M51 04 15

Recall Campaign 15V-450: Side Impact Performance

F56 (Cooper Hardtop 2 Door)

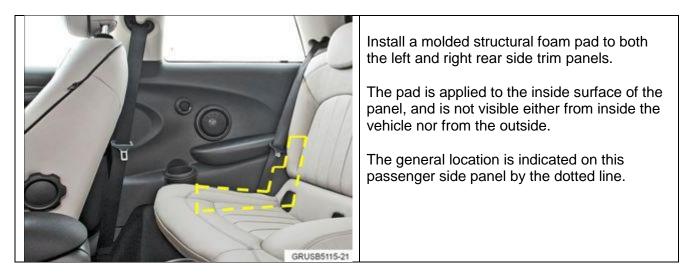
The vehicle's side structure is designed to help absorb energy in the event of a side collision. Due to vehicle build variation, some of the vehicles may marginally exceed a NHTSA test requirement. MINI is performing a voluntary upgrade to these vehicles. Additional energy-absorbing material between the rear interior side panels and the vehicle structure will be added to help enhance occupant protection in the event of a side collision.

Refer to Attachment 2 to modify the side panel and install the structural foam pad.
